RESPONSE TO REQUEST FOR ADDITIONAL INFORMATION

APR1400 Design Certification

RAI No.: 469-8578

Question No. 09.01.01-36

Figure 1 Schematic diagram for distortion of fuel storage cell

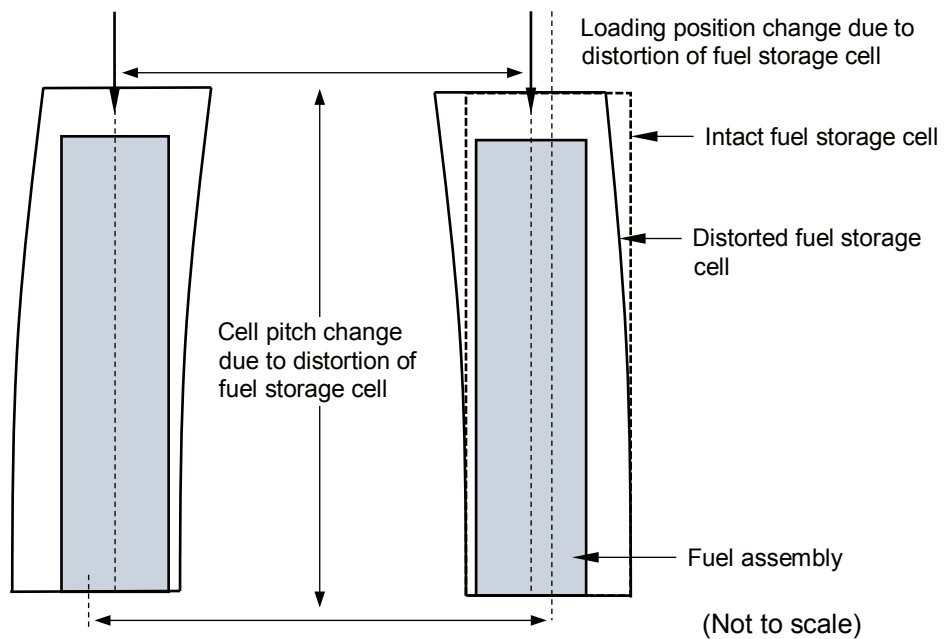
How does the criticality evaluation account for fuel storage cells that are not straight?

The fuel storage cells that are not straight can impact the cell pitches and fuel assembly loading positions as shown in Figure 1. The effects of the cell pitches and fuel assembly loading positions in the criticality analysis were evaluated and included in the total uncertainty as follows.
